**Presentation on the Jackson Bluff Dam Spillway Project**

**RE: Surface Water Management Application 04-2009-0006 I**  
**Jackson Bluff Dam Spillway Modification – Gadsden County**

Re: City of Tallahassee – Corn Hydroelectric Generating Facility  
Spillway Modification Project – Application 04-2009-0006 I  
Request for Information dated October 19, 2009

RE: City of Tallahassee – Corn Hydro Spillway Modification  
Application 20-0296182-001-DF - Request for Additional Information – Item #3

City of Tallahassee  
 C. H. Corn Hydro Facility  
 Attachment 5 - Inflow, Outflow, and Tailwater Elevation (IDF Condition)

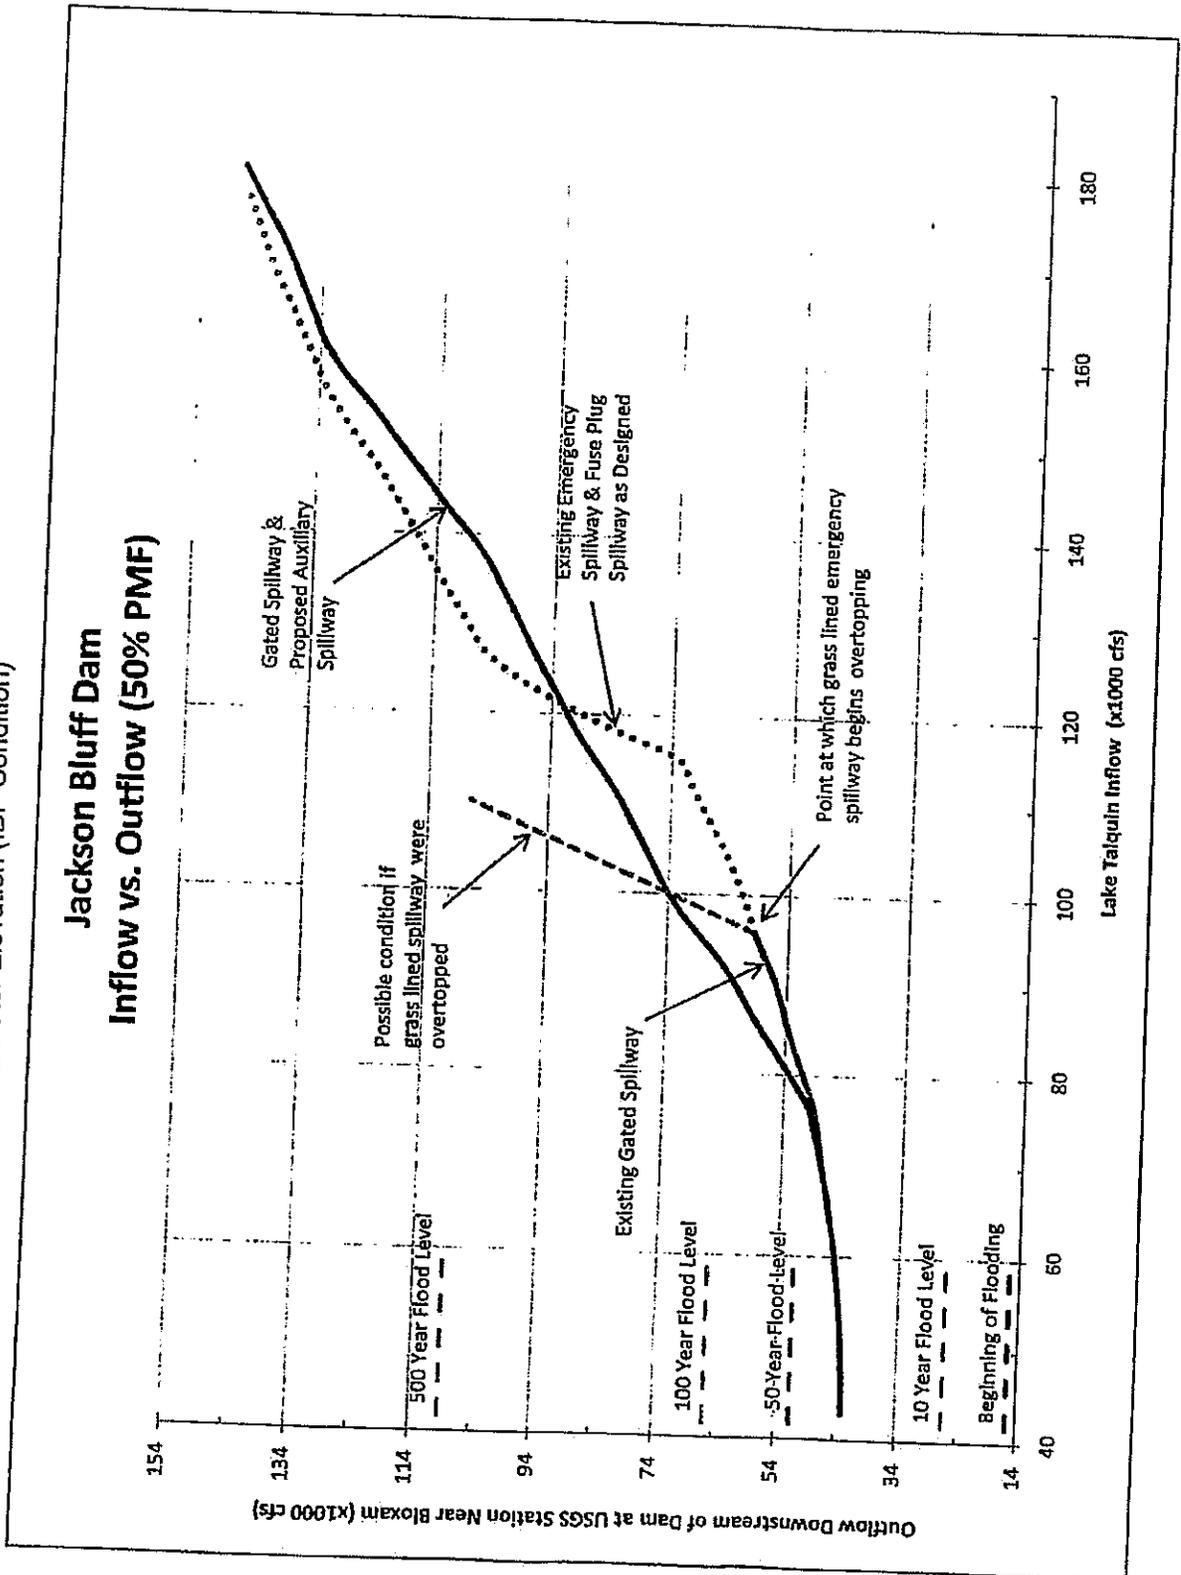
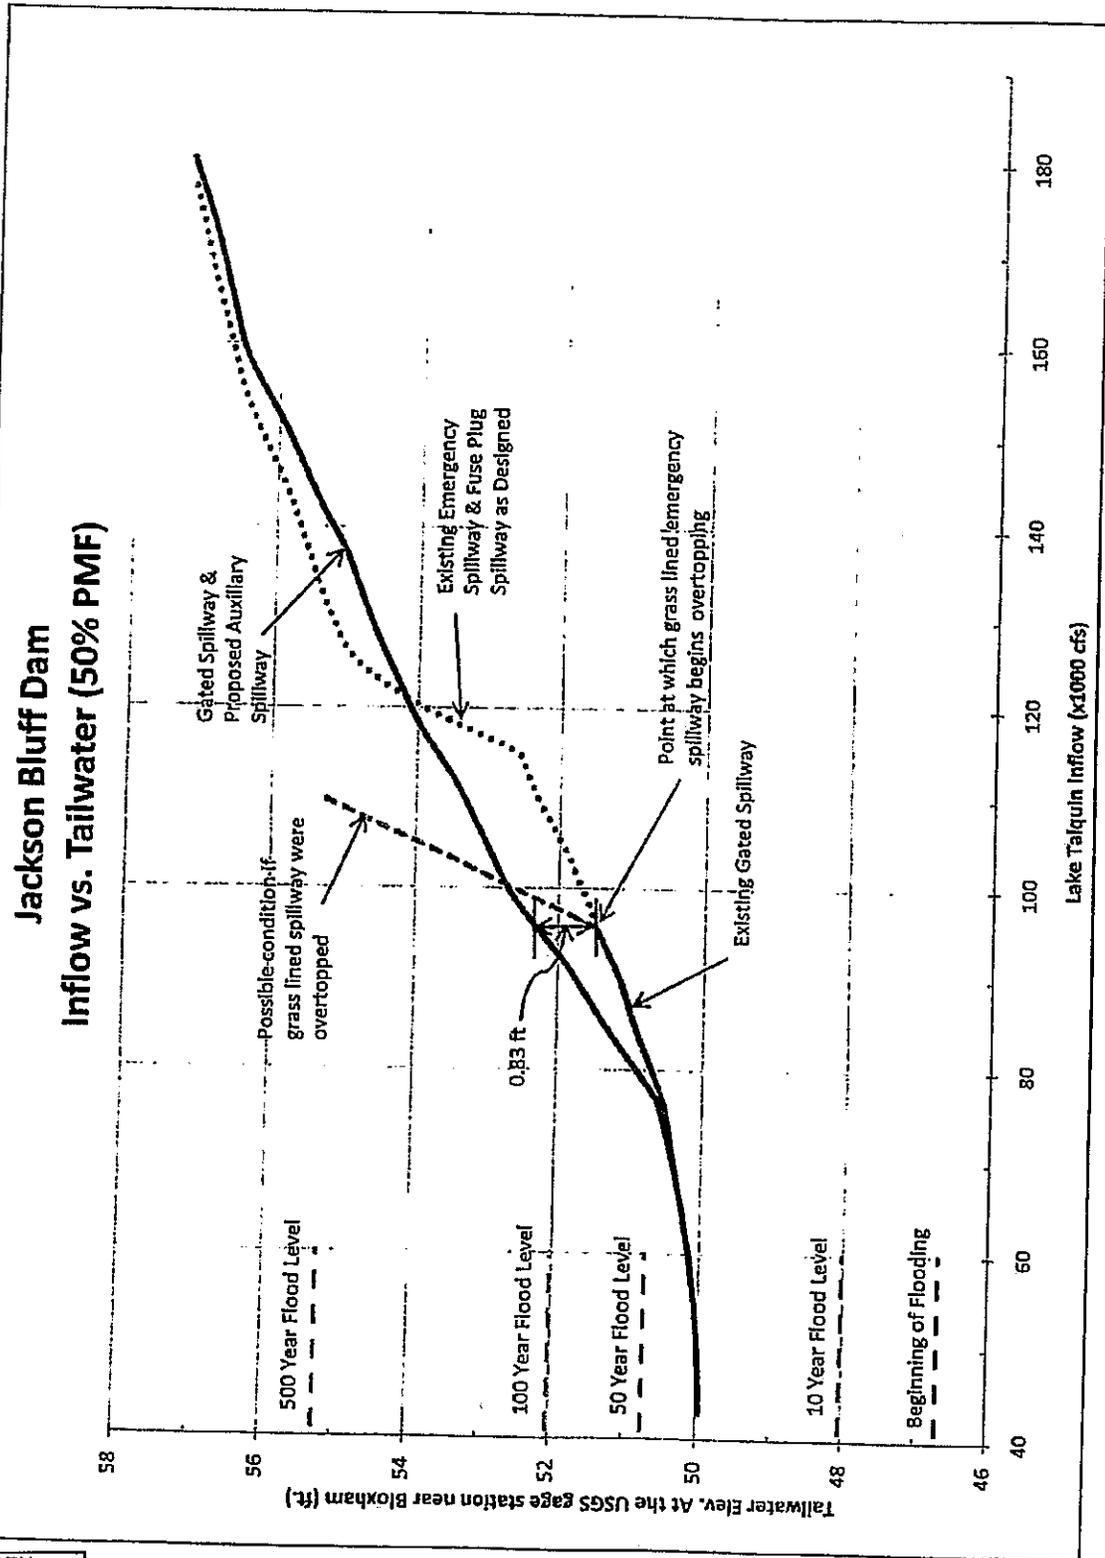
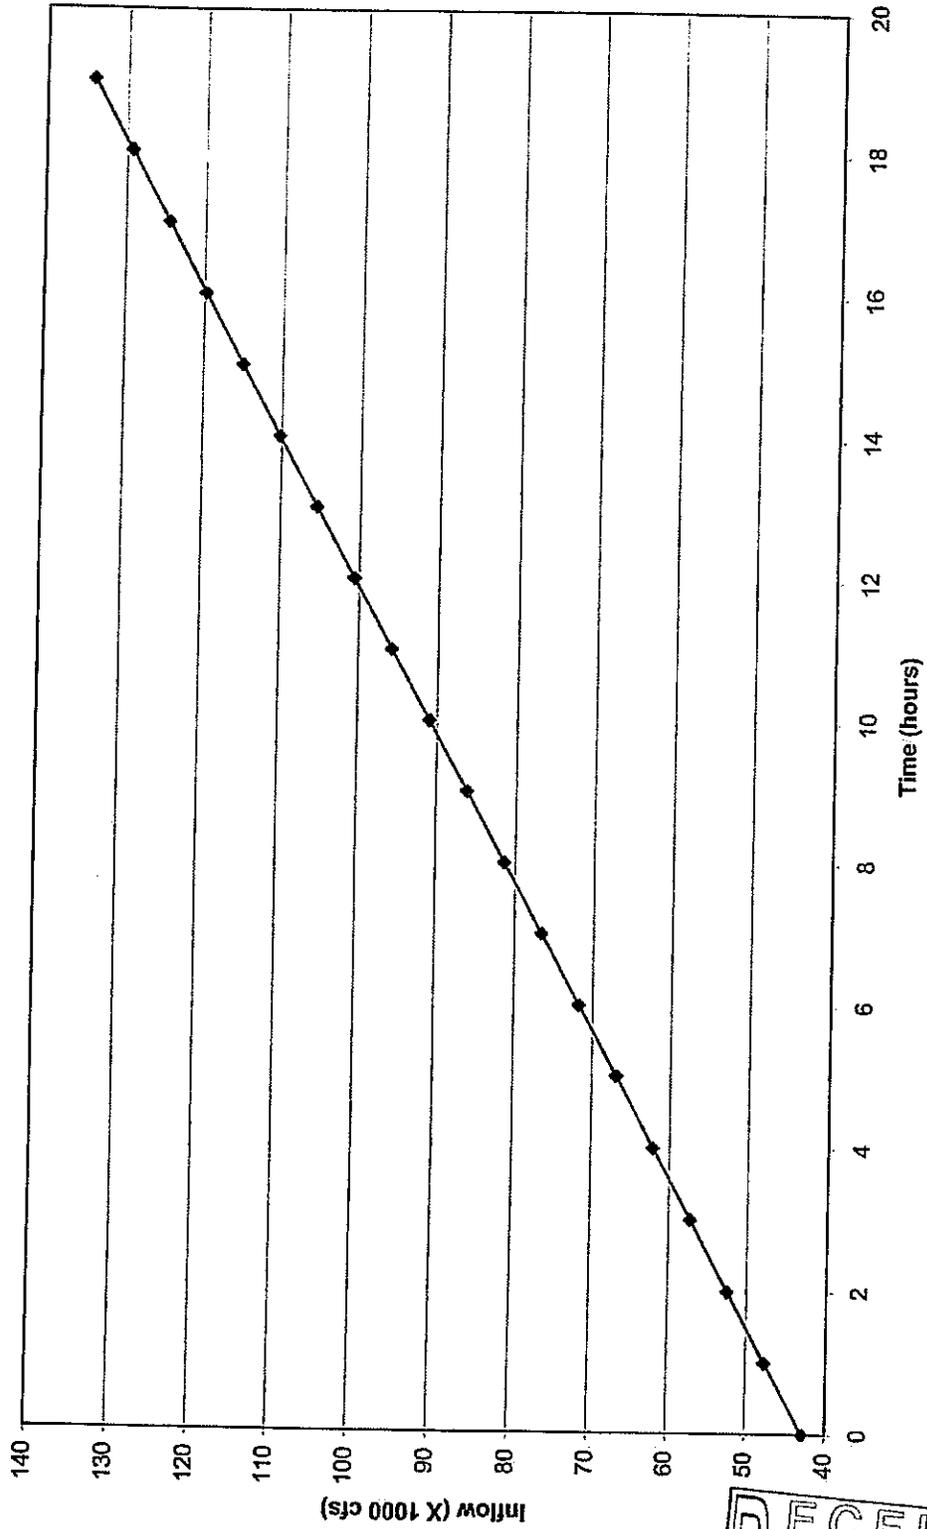
As you know, we recently received an objection letter concerning your project's proposed lowering of the spillway. Please provide a letter clearly stating and justifying that the lowering of the existing invert of the spillway by 2.5 feet will not increase the potential for flood damage to the houses downstream of the dam.

In our response letter dated September 17, 2009, to Northwest Florida Water Management District (NWFWMR), two graphs were included to show the inflow-outflow and the inflow-tailwater level relationships under the IDF (50% PMF) condition (Attachment 5). These graphs compare the two relationships for the existing and proposed designs. These graphs were developed using manual reservoir routing method and the inflow condition was assumed to be simplified linear increasing flow peaking at the IDF. In these graphs, they show a potential for a 0.83-foot increase in the tailwater level (meaning that the tailwater level would be 0.83 feet higher) for the proposed design when the inflow reaches approximately 96,000 cfs, under the simplified IDF inflow condition. This method represented a simplified worse case analysis. The information contained in Attachments 1-4 represent more detailed modeling results and refines the different conditions. As noted above, you will see that this more detailed modeling has identified that the earlier difference was overstated.
